UNITED STATES PATENT AND TRADEMARK OFFICE

APPLICATION NO.	FILING DATE	FIRST NAMED INVENTOR	ATTORNEY DOCKET NO.	CONFIRMATION NO.
10/665,469	09/22/2003	Toshikazu Onishi	60188-660	5515
7590	04/28/2006		EXAMINER	
Jack Q. Lever, Jr. McDERMOTT, WILL & EMERY 600 Thirteenth Street, N.W. Washington, DC 20005-3096				NGUYEN, PHILLIP
		ART UNIT		PAPER NUMBER
		2828

DETAILED ACTION

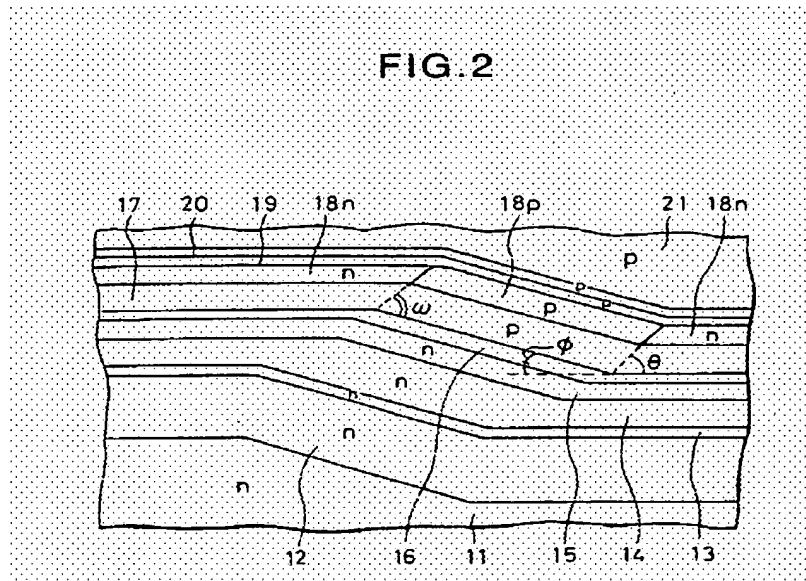
With respect to claims 1 and 4, Anayama discloses in Fig. 2 (above) a semiconductor laser device comprising an active layer; a first cladding layer 17 formed on the active layer, the first cladding layer being doped with first impurity (Mg) and a second cladding layer 18 formed on the first cladding layer, the second cladding layer being doped with a second impurity (Zn) different from the first impurity wherein the first cladding layer has the same conductivity type (p type) as that of the second cladding layers and the first cladding layer has a resistivity higher than that of the second cladding layer due to the thickness and the type of dopants. Anayama also teaches each of first and second cladding layers being made of a compound semiconductor containing phosphorous (col. 8, lines 60-65). It is noted that the claim recites "a first impurity to have a dopant concentration higher than $4 \times 10^{17} \text{ cm}^{-3}$. However, Anayama discloses the range of this dopant being about $1 \times 10^{17} \text{ cm}^{-3}$ to about $4 \times 10^{17} \text{ cm}^{-3}$. Firstly, according to the MPEP section 2144.05 for Obviousness of Ranges as follow:

In this case, for example, if the claimed dopant concentration is just slightly higher ($4.0000000000000001 \times 10^{17} \text{ cm}^{-3}$) than the one disclosed in prior art, there will be no difference in the result. Secondly, Anayama discloses the dopant concentration being in a range "about $4 \times 10^{17} \text{ cm}^{-3}$ ", which maybe slightly lower or higher than the exact $4 \times 10^{17} \text{ cm}^{-3}$. Therefore the claimed range could also be within the disclosed range by prior art.

FIG.5

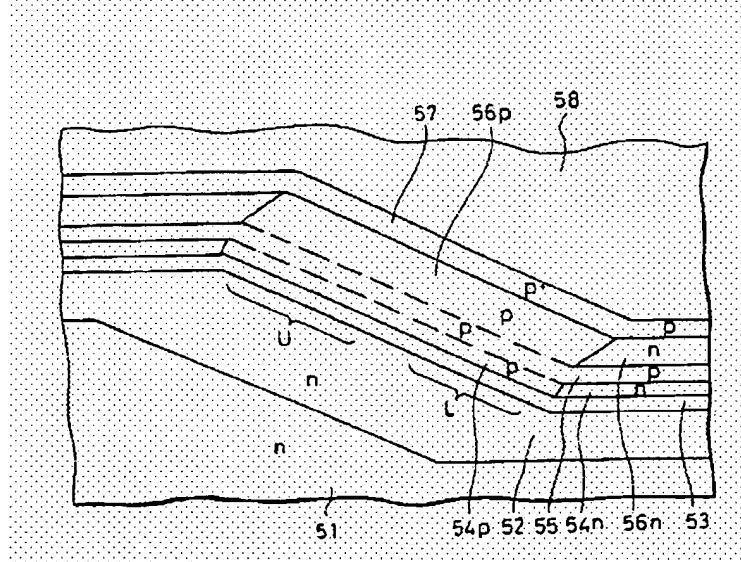
With respect to claim 6, Anayama discloses in Fig. 4 and 5 (above) a laser as claimed in claim 1 with the first cladding 54 and the second cladding 55/56. Besides teaching a first impurity and a second impurity and Anayama also teaches a third impurity (selenium) which creates the n type conductivity on the sides of cladding layer 54 and denoted as 54n.
